Exclusion on N1 vehicles from ASEP, that are bigger N1 derived from N2

6.2.3. Additional sound emission provisions

Exclusion on N1 vehicles from ASEP, that are bigger N1

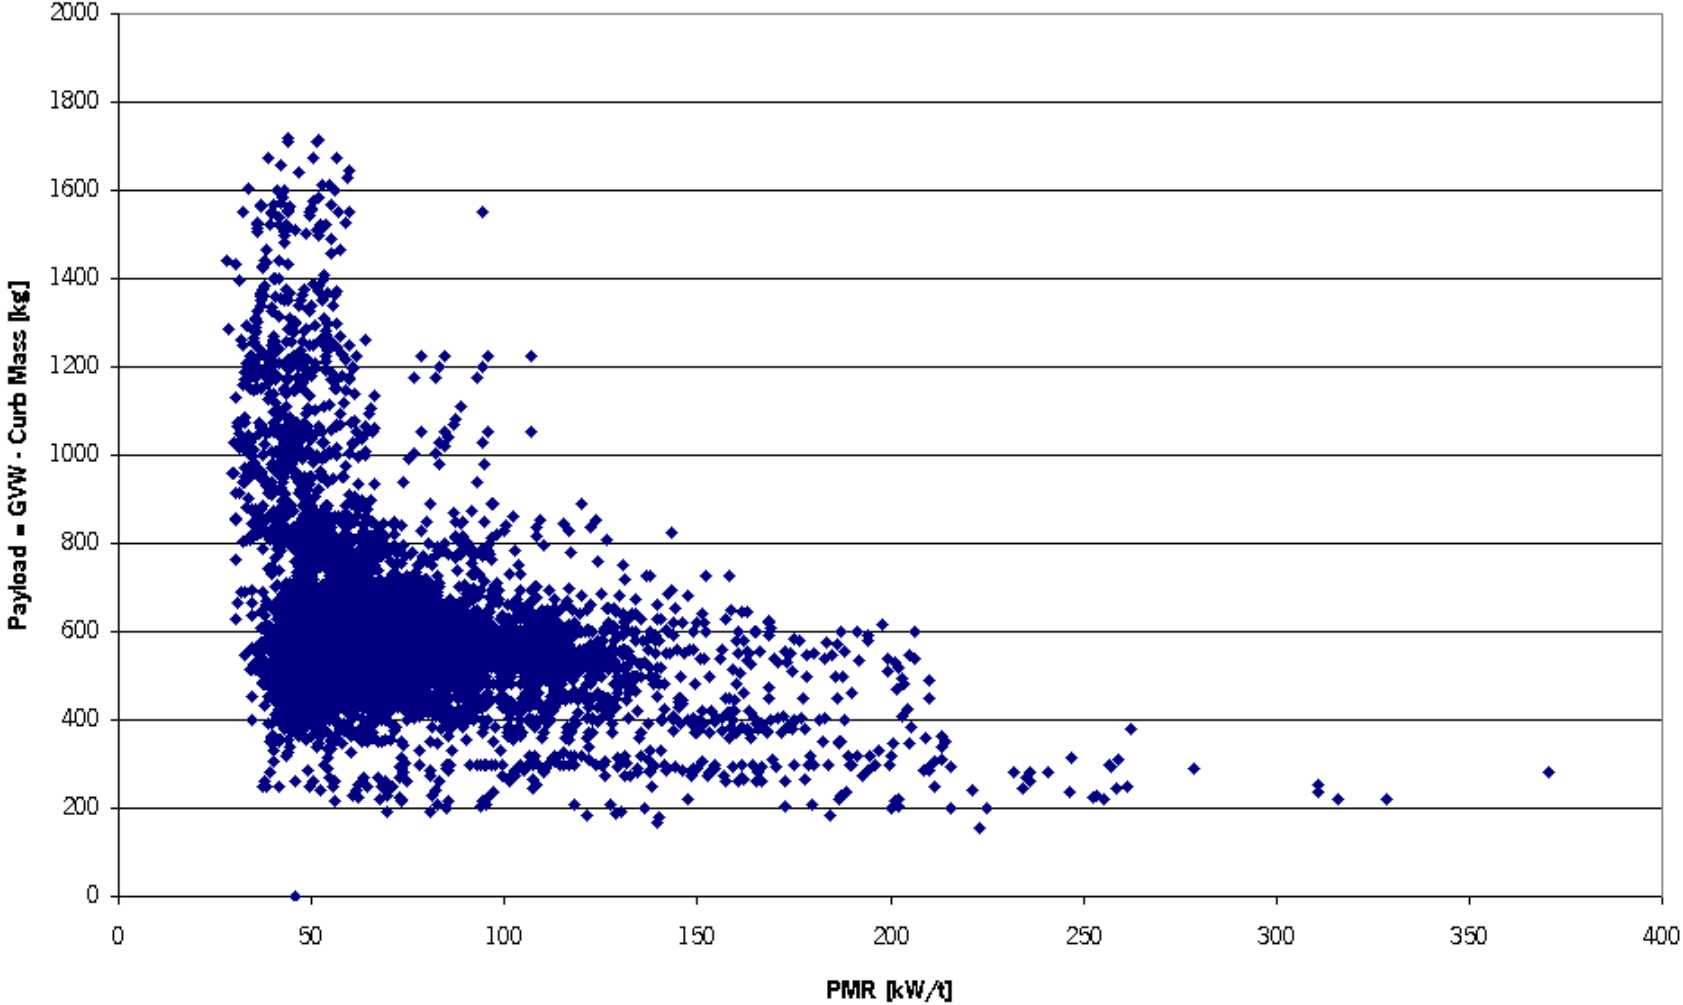
The additional sound emission provisions apply only to vehicles of categories M1 and N1 equipped with an internal combustion engine.

Vehicles of category N1 with a difference of maximal permissible weight and kerb weight above [500 kg] and a PMR lower than [80 kW/t] are not subject of this paragraph.

Focus of ASEP is on vehicles with a potential intension to tune their noise behaviour. This is not given for commercial vehicles. However within the class N1 one can find “normal cars” registered as N1 as well as real commercial vehicles.

This upper approach is a proposal to separate these two groups.
